Re: *FortisBC Inc. (FortisBC) Application for a Certificate of Public Convenience and Necessity (CPCN) for the Advanced Metering Infrastructure Project – Responses to Intervener Information Request No. 3*

FortisBC Inc. (FortisBC or the Company) Application for a Certificate of Public Convenience and Necessity for the Advanced Metering Infrastructure Project	Submission Date: February 22, 2012
Response to British Columbia Sustainable Energy Association Information Request (IR) No. 3	Page 1

Figure 3.1 Simplified European vs. North American Distribution Network Architectures

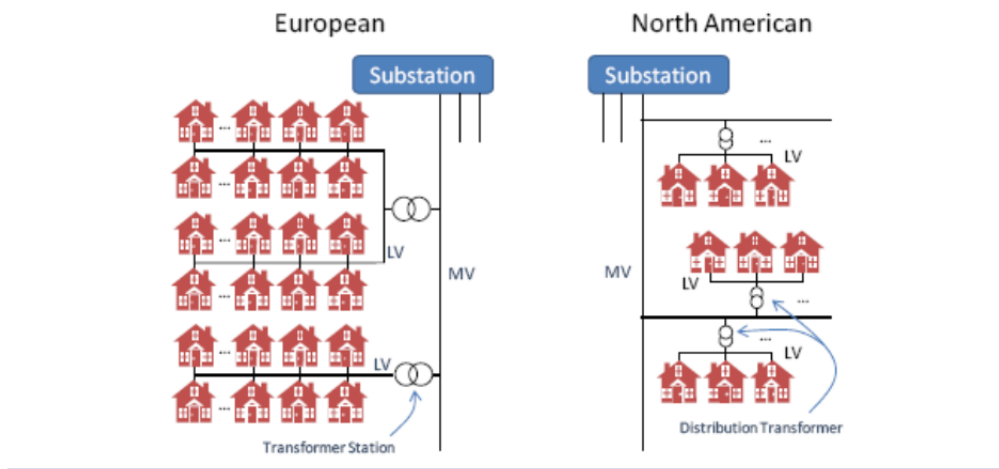
22 113.1 Please confirm that the following is text and graphic from the PikeResearch
23 report immediately preceding the text quoted in Exhibit B-23 that may clarify how
24 the different power system architecture in Europe compared to North America
25 affects the comparative costs of PLC and wireless metering systems:

As illustrated in Figure 3.1, the major difference is the location of the transformers between the medium voltage (MV) network that comes from the distribution substations and the low voltage (LV) networks that feed consumers' homes through the meters. In the North American system, the LV lines are limited in length (a few hundreds of feet), primarily due to the lower service voltage. Therefore, the MV lines are distributed throughout the neighborhoods and the MV/LV conversion is performed by smaller pole-top or pad-mounted distribution transformers serving an average of four to five homes. In the European system, LV line lengths of up to 1 mile may be used, allowing larger, more centralized transformers that support an average of 70 to 100 homes each.

Response:
